**From:** Bill Bardenwerper <wbb@bardlaw.net>  
**Sent:** Tuesday, August 19, 2014 1:04 PM  
**To:** Carroll, John G.; Baker, Jonathan; Reverman, Joe; Liu, Emily  
**Cc:** Stpinlou@aol.com; Nick Pregliasco; gcrawfordjr@yahoo.com; Mark Madison (markmadison@milestonedesign.org)  
**Subject:** Crawford's Rosewood condominiums; Case No. 14PARK1002

**ROSEWOOD ASSOCIATIONS' SUMMARY OF OMITTED & INEFFICIENT DATA  
RELATED TO HRG'S REVISED 7/21/14 SITE PLAN**

# SUMMARY OF OMITTED, INSUFFICIENT, INACCURATE, AND MISLEADING DATA RELATED TO HRG'S SITE PLAN, WAIVER APPLICATIONS, AND PARKING STUDY

#### 8. Private Yard Area

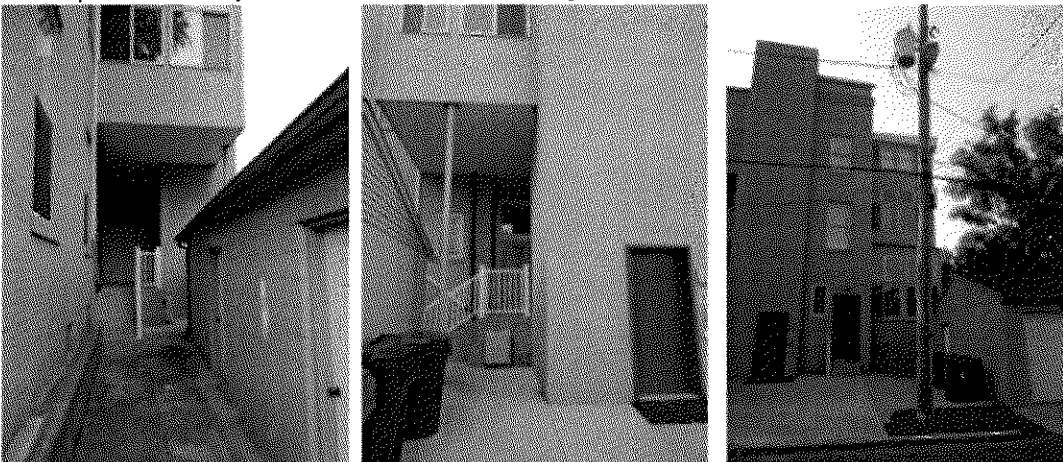
The site plan should provide precise measurements for all claimed PYA in order to verify if HRG actually meets the claimed 3,696 sq ft. The identified areas claimed as private yard cannot possibly add up to this value.

I have included an excerpt of the Association's zoning proposal, which provides an in-depth analysis as to why this attempt to claim the accessory use/service/loading area involves numerous Code violations and entails a direct violation of the owners' property rights.

- a. It appears that HRG is including the 560 sqft. "Rooftop Garden" in the total PYA of 3,696. Based upon our February meeting with the directors of C&R and PDS, the roof deck was explicitly disallowed. Have the directors revised their position? Either way, HRG must exclude the roof deck from the PYA or apply for a waiver.
- b. Does the area marked TBR mean "to be reviewed"? If so, please note that Section 5.4.1.E.2. requires a minimum rear setback of 5 feet "that *cannot* be counted toward the private yard requirement." [see attached photo of site plan. Approximate 5 ft. line depicted by dotted red line]. HRG must exclude the 5 ft. rear set back or apply for a waiver. Also note that the site plan does not identify the utility pole/transformer located on the left side of the service area [see below photo].

- c. Section 5.1.7 states that "every part of the required yard shall be *open to the sky*." There are two areas claimed as PYA that are completely covered by the floor area of an enclosed rear sun room on the second floor [see attached photo of site plan. Areas outlined in red are covered by the sun room as depicted in below photos. Utility area is also outlined in red]

Very specific PYA measurements would be extremely helpful. The site plan does not indicate how HRG can meet the minimum PYA requirement of 3,592 sqft. Based upon measurements from previous site plans, the disallowed areas in red and black are over 700 sqft. If the roof deck is also rightly excluded, that's another 560 square feet. HRG is short at the very least by 1,260.

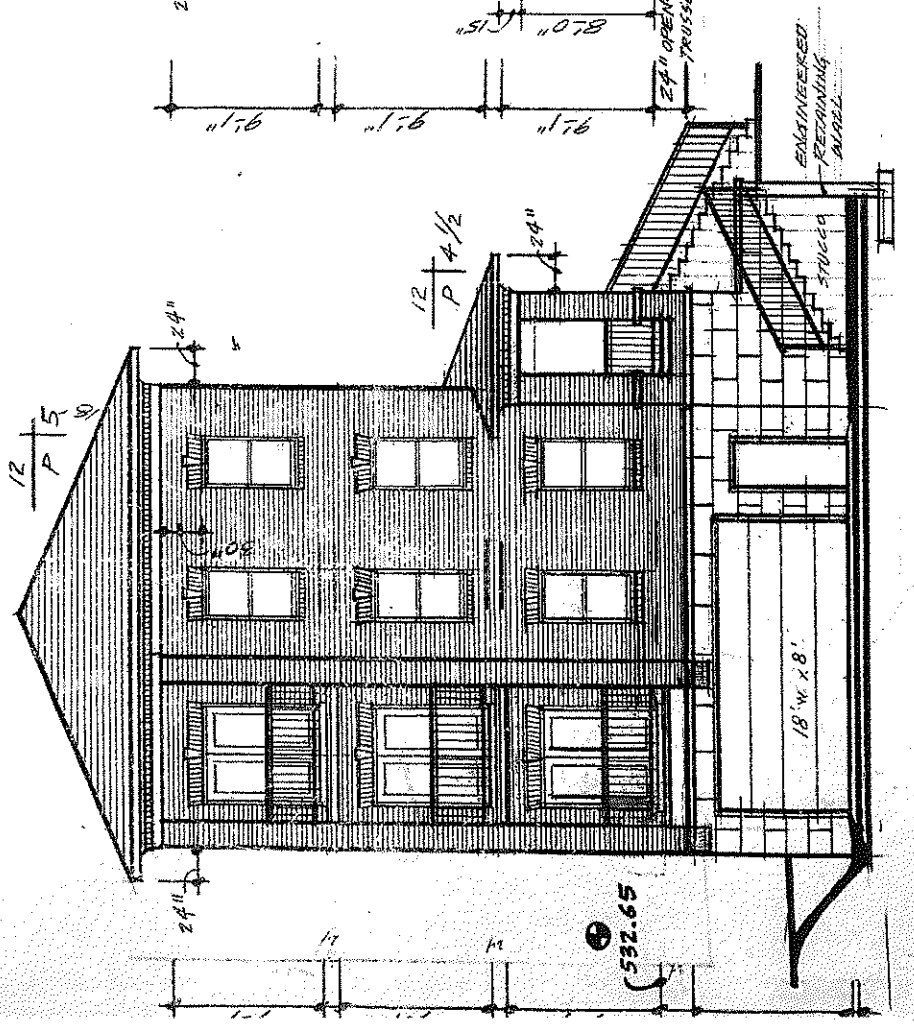
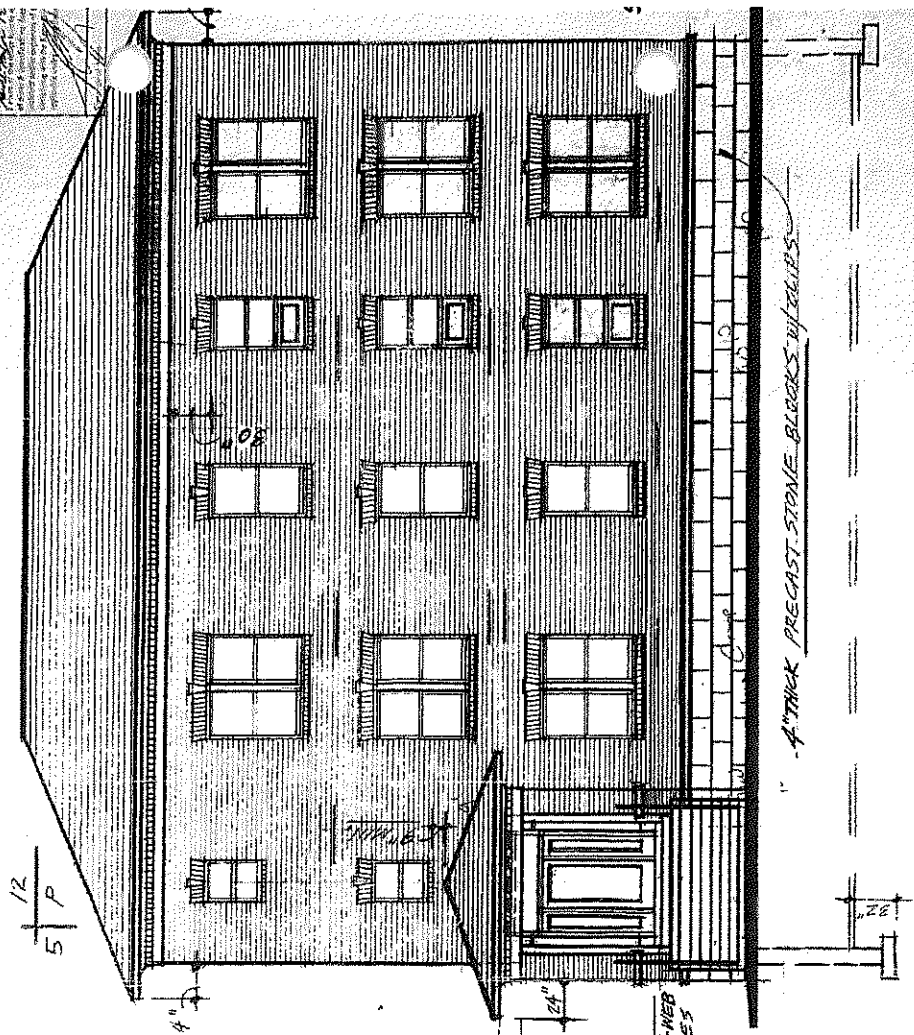
Could you please verify some required dimensions that are missing from the revised site plan?

1. the distance of the front setback from the front property line to the building's facade
2. the dimensions for both the porch and front steps area
3. the length of the front building facade (I know that it measures 28 ft. in the back but previous plans showed a narrower front with the building expanding slightly in the rear).
4. the building's exact physical height from its foundation to the highest point of the roof
5. whether there will be a grade change that would effect how tall the building would eventually stand
